M54 to M6 Link Road

TR010054

**8.8 P(A) Draft Statement of Common
Ground with Environment Agency**

Version	Date	Status of Version
4 (P06)	8 January 2021	Issue to the ExA at Deadline 4

Figure 1

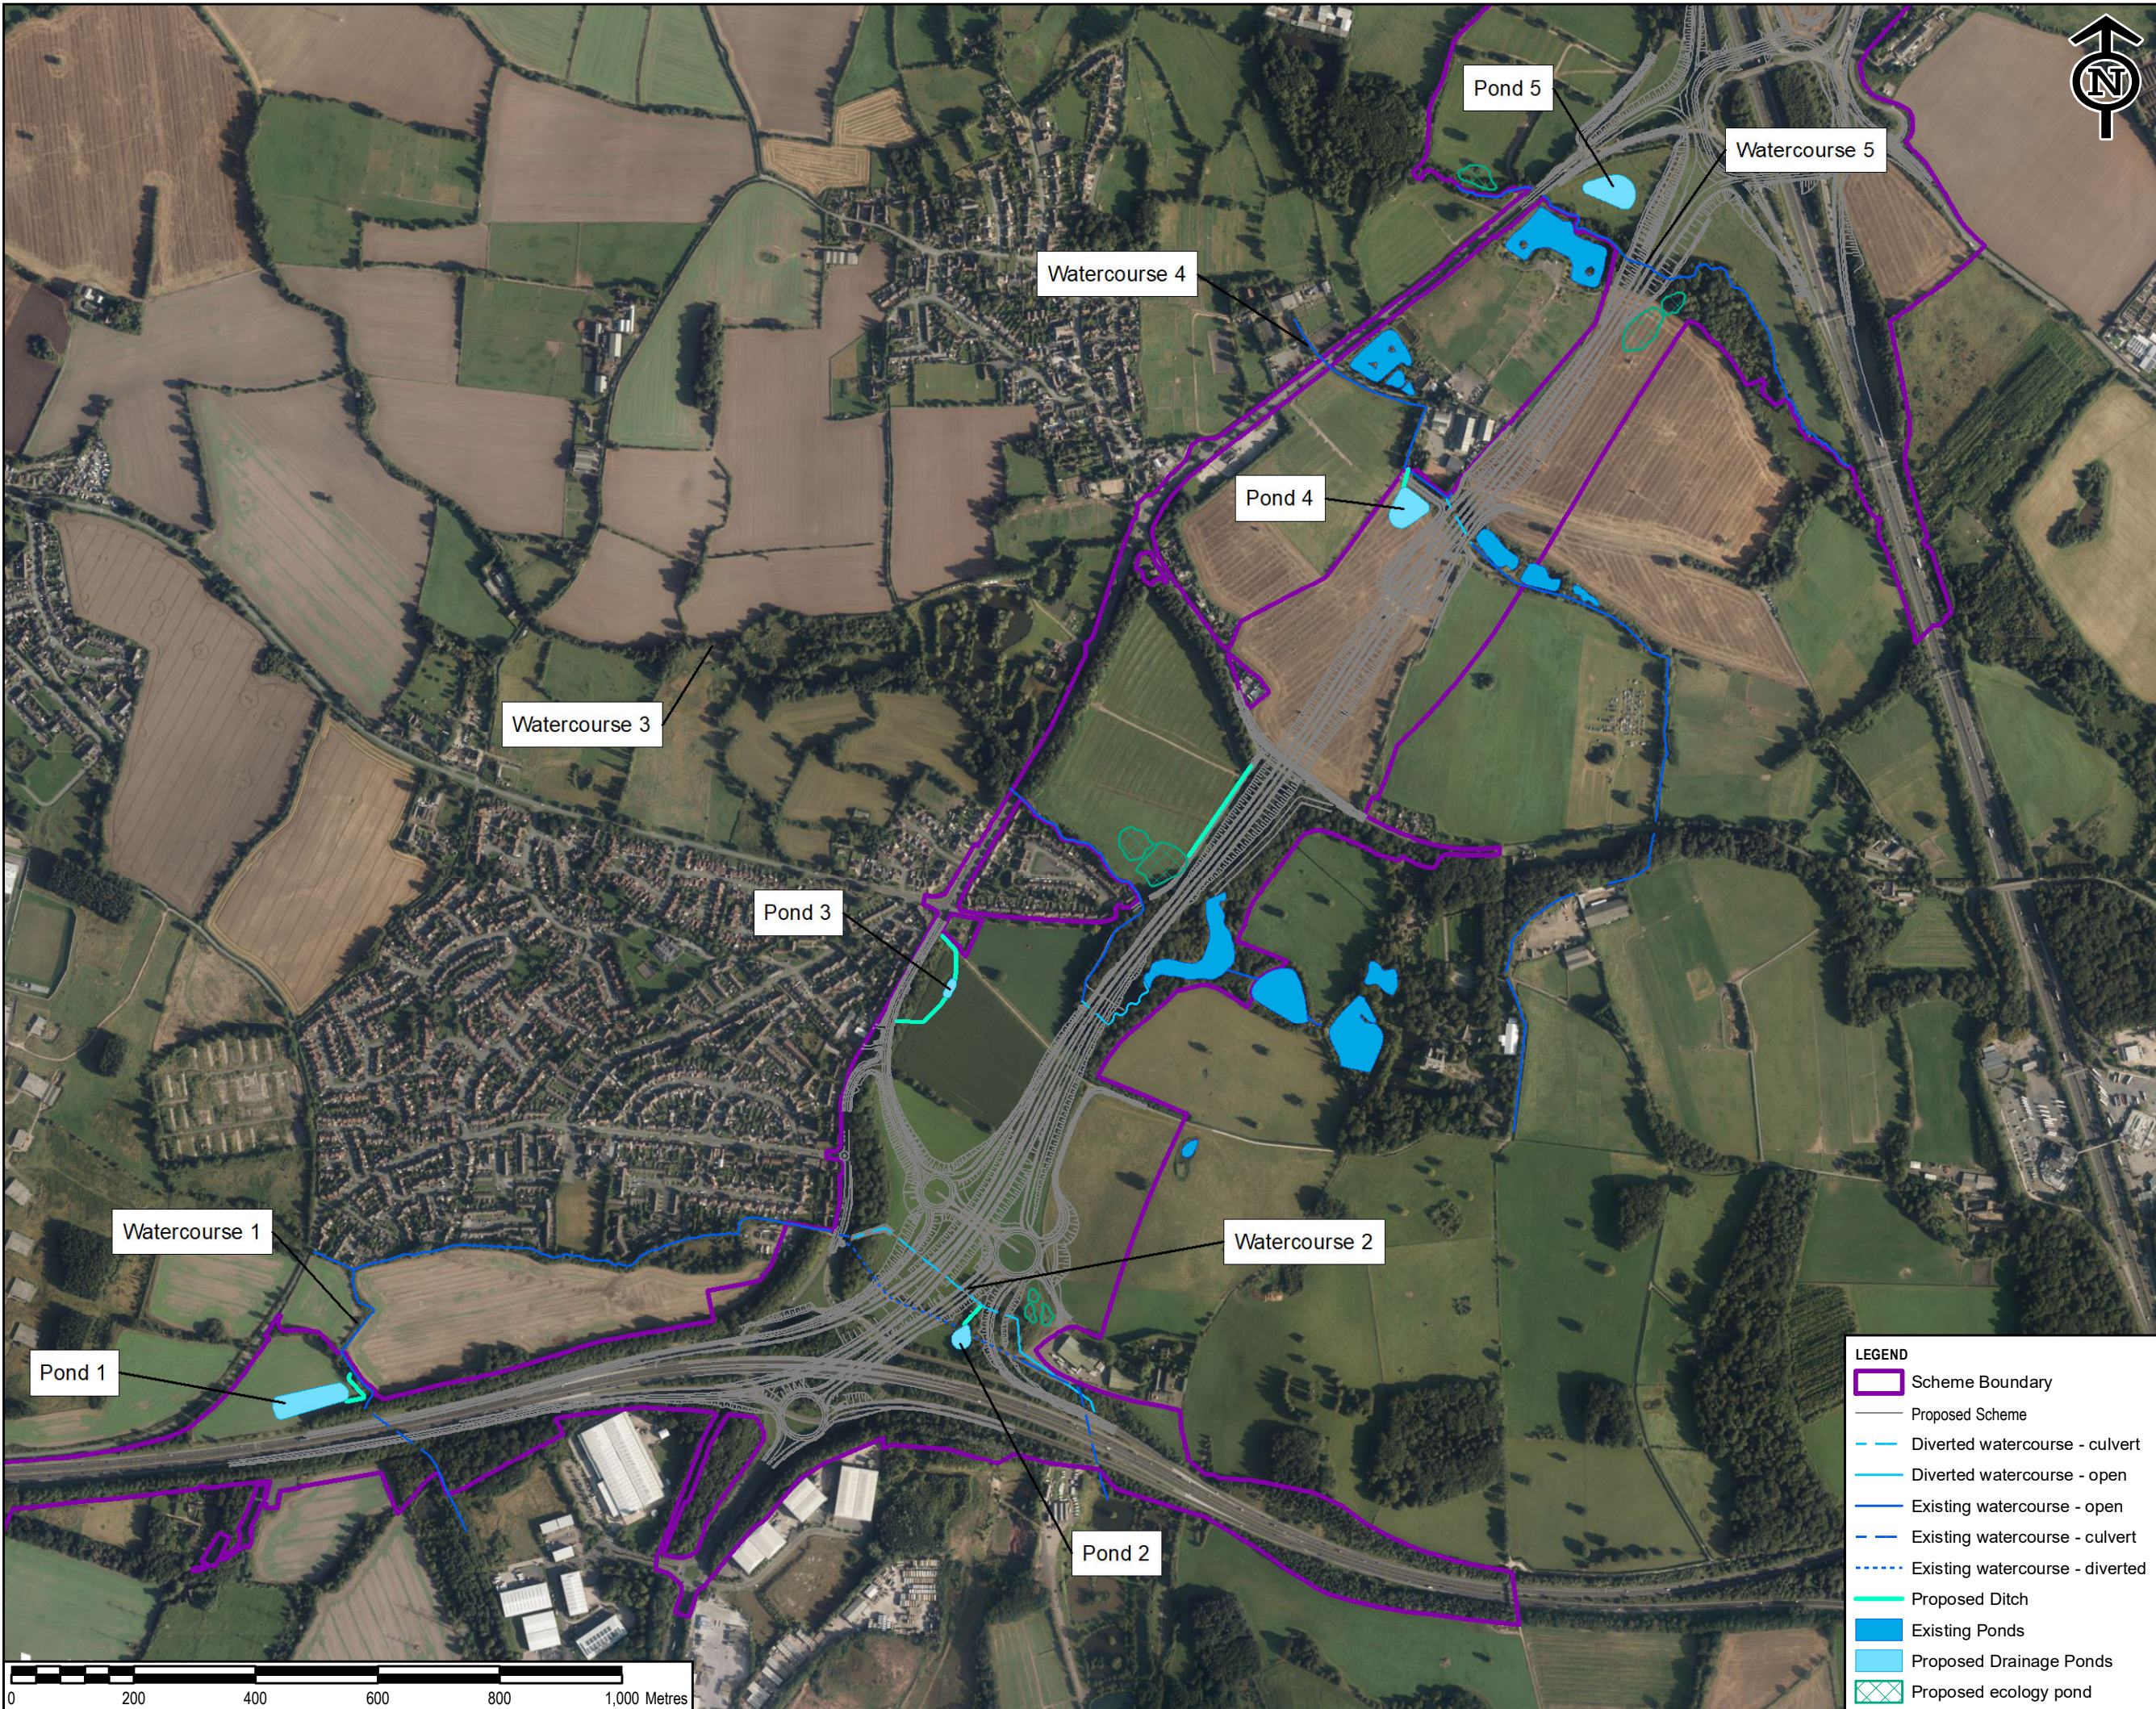
ES Chapter	Paragraph Reference	Sub-section	Environment Agency Comment	Highways England Response	Status	Agreement likely?	
						APP? ¹	IP?
				<p>the proposed culverting represents around 4% of the channel length (this was previously reported as 6% but has now been measured more precisely). As a proportion of the length of the River Penk WFD water body as published in the RBMP the proposed culverts represent around 1.5% of the channel length. However, as the proposed culvert is not on the main stem but on an associated tributary, it would be most appropriate to consider the impact as a proportion of the WFD water bodies main stem plus estimates for all other main tributaries to that WFD water body (taking into account an estimation for other existing culverts). When this is done the proportion of the total catchment channel length affected is only approximately 0.5%. Due to the small proportion of the total WFD water body catchment channel length impacted by the proposed culverts to Watercourse 2, the design of the culvert (which seeks to minimise adverse impacts on hydromorphological processes), and the compensation for the loss of riparian habitat provided by new ditchcourses (e.g. from Ponds 1 and 2), an overall minor adverse and localised impact is predicted, that would not be significant at the water body level</p>

ES Chapter	Paragraph Reference	Sub-section	Environment Agency Comment	Highways England Response	Status	Agreement likely?	
						APP? ¹	IP?
				<p>(i.e. no deterioration of the WFD status of the water body).</p> <p>As a proportion of Watercourse 3 and Watercourse 4, the proposed culverting represents around 1% and 2% of the total channel length of these Watercourses, respectively. When the proportion of the channel impacted along Watercourse 3 and Watercourse 4 from new culverts is estimated using the length of the Saredon Brook WFD water body as published in the RBMP the proportion affected reduces to around 0.4%. However, as described above, it would be most appropriate to consider the impact as a proportion of the WFD water body main stem plus estimates for all other main tributaries to that WFD water body (taking into account an estimation for other existing culverts). When this is done the proportion of the total catchment channel length affected is around 0.3%. Due to the very small proportion of the total WFD water body catchment channel length impacted by the proposed culverts to Watercourse 3 and Watercourse 4, the design of the culverts (which seeks to minimise adverse impacts on hydromorphological processes), and the compensation for the loss of riparian habitat provided by</p>

ES Chapter	Paragraph Reference	Sub-section	Environment Agency Comment	Highways England Response	Status	Agreement likely?	
						APP? ¹	IP?
				<p>new ditchcourses (e.g. from Ponds 3 and 4) plus the new channel proposed for Watercourse 3 (following relocation of the current impoundment structure for Lower Pool), an overall minor adverse and localised impact is predicted, that would not be significant at the water body level (i.e. no deterioration).</p> <p>With regards to the comment about culverting being a 'high' risk activity, Highways England has detailed in other technical responses how the adverse impact of culverts will be mitigated and compensated for.</p> <p>A summary of the WFD Assessment has been produced which sets out the impact on each of the WFD criteria for each watercourse, how this impact is mitigated and where this is secured by the DCO. It includes details of the watercourses measures when determining the percentage of channel impacted by culverts within each WFD water body catchment. This was submitted to the EA for comment on 22 December 2020.</p>
